SUBJECT: NuScale Power, LLC Supplemental Response to NRC Request for Additional Information No. 134 (eRAI No. 8934) on the NuScale Design Certification Application

RAIO-0818-61563

Response to Request for Additional Information Docket No. 52-048

NRC Question No.: 03.07.02-15

Figure 1-2. RXB Plan View Showing Hydrodynamic Loading on Pool Walls (in red).

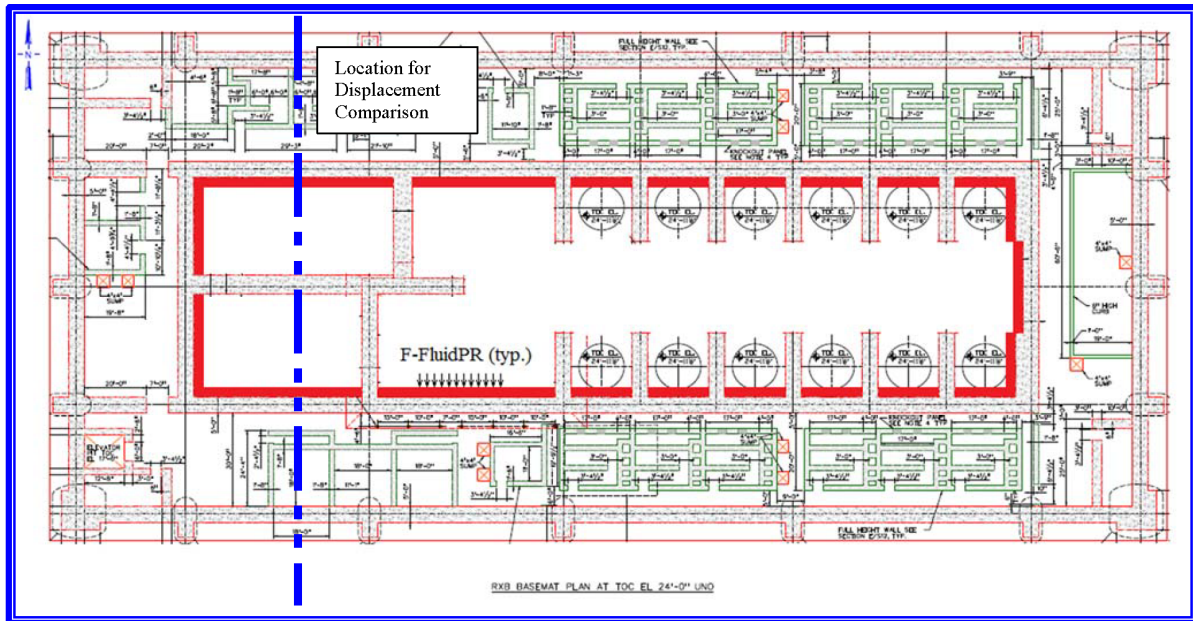
Therefore, the applicant is requested to provide figures or tables that compare pressure profiles on the pool walls and foundation obtained from the actual missing FSI pressure and from amplifying the gravity load by a factor of 1.28. If significant differences are identified in such comparison, the applicant should provide an evaluation demonstrating that the use of a gravity load factor of 1.28 results in an incremental design demand (forces, moments, deformations, etc.) that would have bound the increased demand should the applicant have used the actual pressure profile accounting for the missing FSI effect in SAP2000, for both the RXB pool walls and foundation.

Response: NuScale has performed analyses that confirm that the 1.28 x gravity load bounds a 4.2psi pressure profile and is providing these results as part of this response.

Figure 1-1 shows a cross-sectional elevation view of the RXB and the inertial loading in the vertical direction. Figure 1-2 shows a cross-sectional plan view of the RXB and the fluid pressure loading in the horizontal direction. Figure 1-3 shows a cross-sectional plan view of the RXB and the fluid pressure loading in the vertical direction. Figure 1-4 shows a cross-sectional elevation view of the RXB with the combined soil pressure and fluid pressure for the static portion of ACI Equation 9-6.

Figure 1-4. RXB Elevation View Showing Soil Static (orange), Horizontal Hydrostatic (blue), and Vertical Hydrostatic Pressure (green).

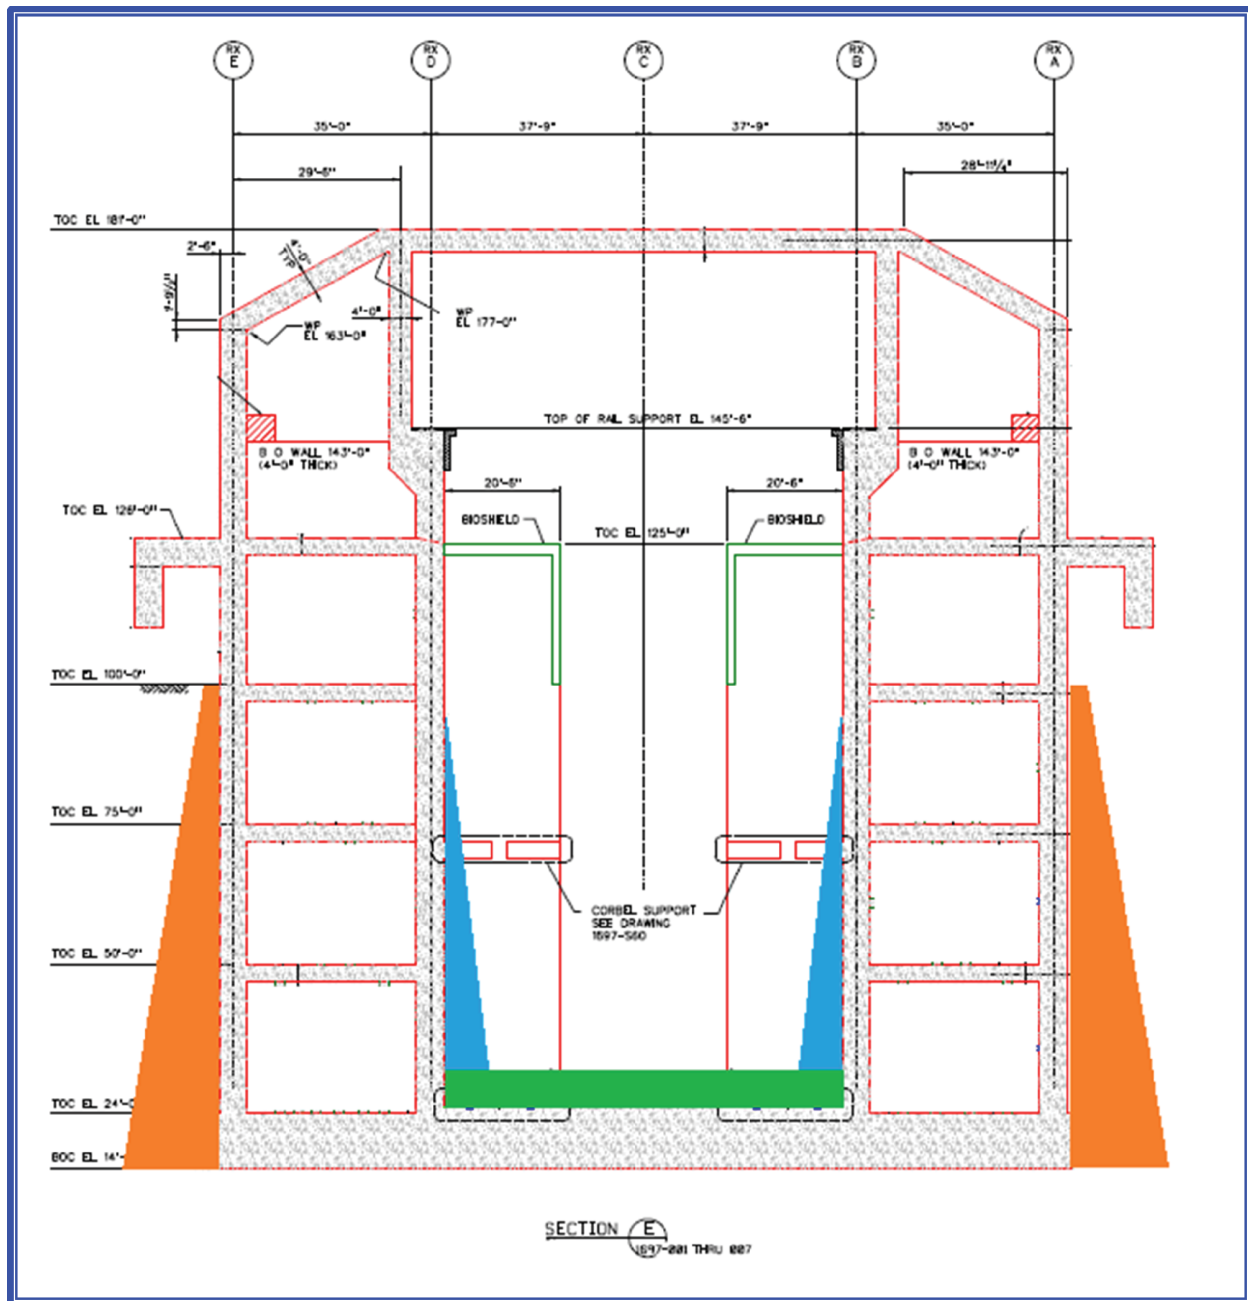
During a Public Meeting on May 29, 2018, the NRC asked NuScale to submit a supplement to RAI 8932 question 03.07.02-15 to clarify the distribution of pressure on the foundations in figure 3.7.2-129, and to explain how the hydrostatic load is applied. Additional NRC comments were received during a Public Meeting on June 12, 2018 on hydrodynamic pressure accounting for 3D FSI effects prior to the meeting.

4. Additionally, clarify whether the hydrostatic water pressure described in FSAR Section 3.8.4.3.2 is addressed in SAP2000 by applying an actual pressure profile to the pool walls and foundation or by the use of a gravity load factor. If the latter, address the adequacy of the use of a gravity load factor as requested in item a above also in the context of hydrostatic pressures.

pressure was added to the SAP2000 model by amplifying the gravity load by a factor of 1.28. Because the applied horizontal hydrostatic wall pressure varies linearly with water depth, the walls below mid-height of the pool, as well as the foundation, will experience greater than 4.2 psi hydrostatic pressure, as illustrated in FSAR Figure 3.7.2-129. This is a conservative approach to capturing the "missing" hydrodynamic pressure.

Response: As described above, the hydrostatic pressure distribution is applied as a surface pressure to all wetted area elements in the SAP2000 model. The “missing” hydrodynamic pressure was added to the SAP2000 model as an equivalent static load by amplifying the gravity load by a factor of 1.28. NuScale has performed analyses that confirm that the 1.28 x gravity load bounds a 4.2psi pressure profile.
